**CITY OF PORTLAND, MAINE
DEVELOPMENT REVIEW APPLICATION
PLANNING DEPARTMENT PROCESSING FORM
Planning Copy**

Brooklawn
Project Name/Description

Woodard & Curran has reviewed the site plan submission for the proposed maintenance building at Brooklawn Memorial Park. An existing building will be replaced with a new 4800 square foot structure. The new building will be constructed behind the existing structure, which will be demolished following construction.

**RE: Minor Site Plan Review: 2002 Congress Street
Construction of Maintenance Building
Application # 2008-0009; CBL 211 A001001**

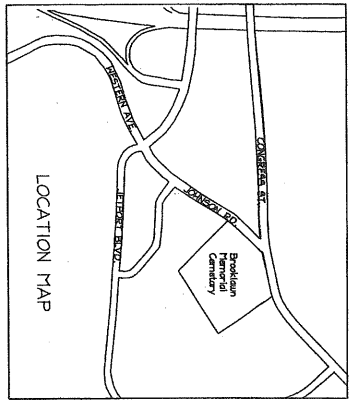
2. Provide details on hydrant shown on the site plan. ie main size and recent flow test results.

5. Site plan submitted does not show any roads or access lanes. Provide details for Fire Dept access.

3. Please clarify the total land area of the site. Submit a site plan that shows the entire lot and states the total land area of the site.

4. Show all the utilities lines should be shown on the plans. Will there be a water and plumbing in the proposed building? If yes, we will need water and sewer capacity letters from Portland Water District and the Department of Public Works, respectively.

THE ROADS AND ACCESSES WILL NOT CHANGE AS A RESULT OF THIS PROJECT. THE ROADS HAVE BEEN MORE CLEARLY IDENTIFIED ON THE NEW SET OF PRINTS.

THE UTILITY LINES HAVE BEEN ADDED TO THE PLANS. THERE IS NO PLAN FOR WATER AND PLUMBING IN THE NEW BUILDING. THERE WAS NO WATER AND PLUMBING IN THE OLD BUILDING.
